Office Action Summary

10/532,809

YAMADA, SEIJI

DETAILED ACTION

8a, Shown below: note: The mold shown in the Figure 8a is similar to that shown in FIG. 4 and the same reference numerals are used for equivalent parts).

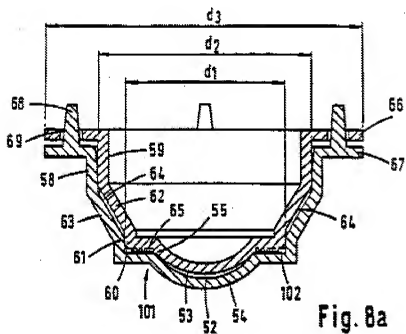
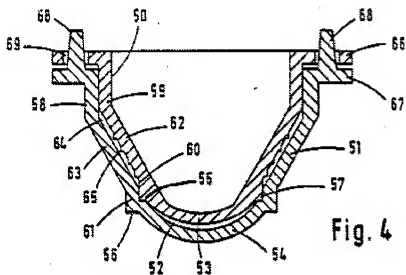
a. With respect to claims 1, 3 and 5-6, Seden et al. teach a contact lens forming die comprising male and female dies (all elements refer to Fig. 4, and

Mold halves 50 and 51 constitute the male and female halves. The cavity is shown by element 52 which is adapted to be filled with polymerizable monomer (see abstract). The annular flat area formed abutting 55-56 of fig. 4 may range from 0.1 mm to 0.2mm and is orthogonal to the mating direction. Elements 58 and 59 form fitted tubular parts. Seden et al. teach an auxiliary cavity 65 (roughened forming snatch rings). Seden et al.'s Fig. 4 elements 55 and 61 show abutting surfaces are orthogonal to the mating direction. Fig. 8a shows reservoir located between shoulders 55 and 56 but does not have abutting surfaces orthogonal to the mating surfaces. Seden et al. fail to teach the combination of an abutting surface orthogonal to the mating direction with an auxiliary reservoir in one embodiment. However, it would have been obvious to the person having ordinary skill in the art to provide an auxiliary cavity with the abutting surfaces (55,56) which are orthogonal to the mating direction for an embodiment illustrated in Fig. 4 or to use an unroughened (i.e. flat) instead of roughened surface (65) for an embodiment shown in figure 8a thereby forming abutting surfaces in addition to the auxiliary cavity in Seden et al.'s invention, because Clutterbuck, drawn to a contact lens forming die of the type taught by Seden, teaches an embodiment in Fig. 1a, element 119 that provides an auxiliary cavity with abutting surfaces orthogonal to the mating direction to provide overflow channel for excess material and also provide formation of edge flat on the cast lens edge that lifts the front and back lens edge away from the wearer's conjunctiva smooth (col. 3 lines 18-27). Moreover, absent any showing unexpected benefit, a preference on whether to provide an auxiliary cavity to an embodiment illustrated in figure 4 similar to an embodiment shown in figure 8a or to

provide an unroughened (i.e. flat) abutting shoulders (55, 56) similar to an embodiment shown in figure 4 is taken to be well within the purview of choice in the art.

As for Claim 7, Seden et al's tubular fitting portion is adjacent to the peripheral edge of the auxiliary cavity (see Fig. 4- elements 58 and 59).

As for Claim 8, Seden et al.'s reservoir is formed by elements 62 and 63 of Fig.4.

As for Claim 9, the discussion on the limitation in claim 1 is incorporated herein. As for the added process limitation, Seden et al.'s mold cavity 52 in Fig. 4 receives a measured volume of polymerizable monomer. (see Col. 5, lines 25-26). Furthermore, it states, "in the operation of the process of the present invention the lenses are cast within their mould cavities, opened after the appropriate polymerisation and curing time has been completed" see (col. 9, lines 3-5).

As for Claim 10, see Fig 4 of Seden et al which clearly shows the mating direction is vertical in order to form a contact lens.
